BAYOU ISLAND SUBDIVISION

The purpose of this application is to resubdivide two lots into eight lots of record.

APPLICATION NUMBER 16 DATE September 16, 2004

DETAIL SITE PLAN

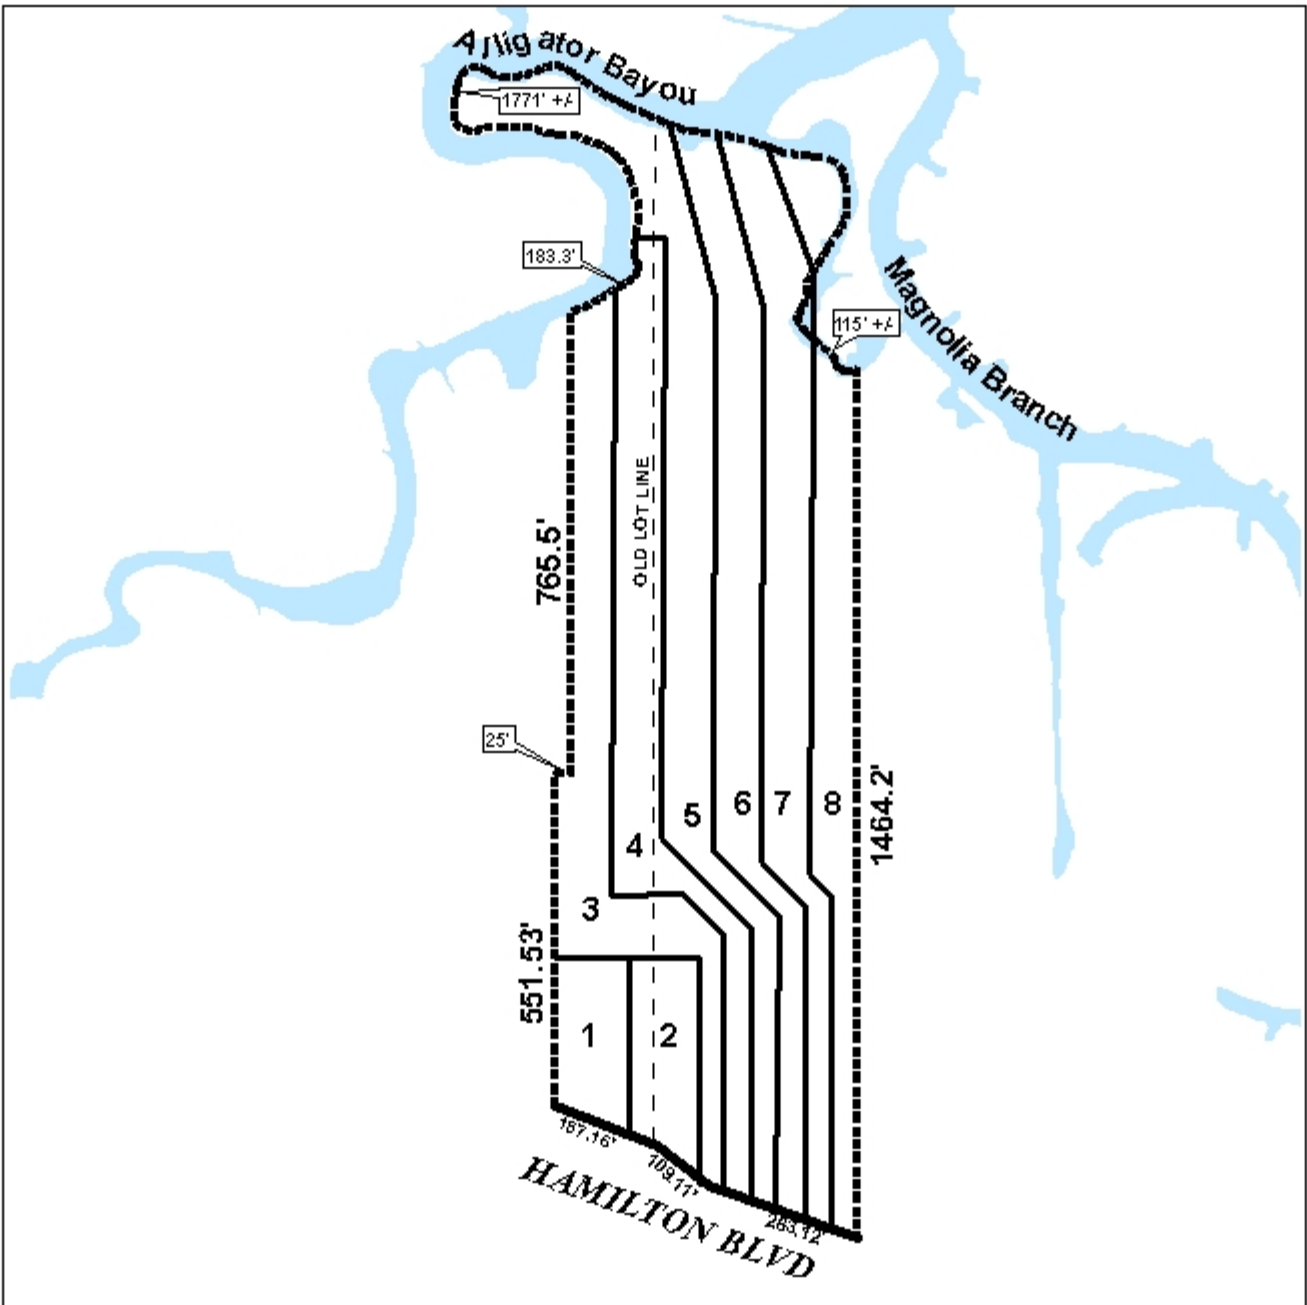
The site fronts Hamilton Boulevard, a planned major street, and the existing right-of-way is shown as variable. The Major Street Plan requires a 100-foot right-of-way; therefore, the dedication of sufficient right-of-way to provide 50-feet from the centerline of Hamilton Boulevard should be required. Additionally, as a means of access management, a note should be placed on the final plat stating that the location, size, and design of all curb cuts are to be approved by County Engineering.

Lots 3 through 8 exceeds the maximum width to depth ratio as recommended by the Subdivision Regulations; therefore, a waiver of Section V.D.3., would be required. Narrow, deep lots are typical along waterways; thus a waiver of V.D.3. could be considered appropriate. However, Lots 3 through 8 are only 45-feet wide, and while narrow deep lots are common along waterways, these types of lots typically comply with the minimum width requirements (60-feet wide) as specified in Section V.D.2. of the Subdivision Regulations. Therefore, the lots should be adjusted such that each lot is 60-feet wide.

The 25-foot minimum building setback lines along Hamilton Boulevard are not shown but would be required on the final plat.

With modifications and a waiver of Section V.D.3., the plat will meet the minimum requirements of the Subdivision Regulations and is recommended for Tentative Approval subject to the following conditions: 1) the dedication of sufficient right-of-way to provide 50' from the centerline of Hamilton Boulevard; 2) the placement of a note on the final plat stating that the location, size, and design of all curb cuts are to be approved by County Engineering; 3) the approval of all applicable federal, state and local agencies prior to the issuance of any permits; 4) that each be a minimum of 60-feet wide; and 5) the placement of the 25-foot minimum setback lines on the final plat.
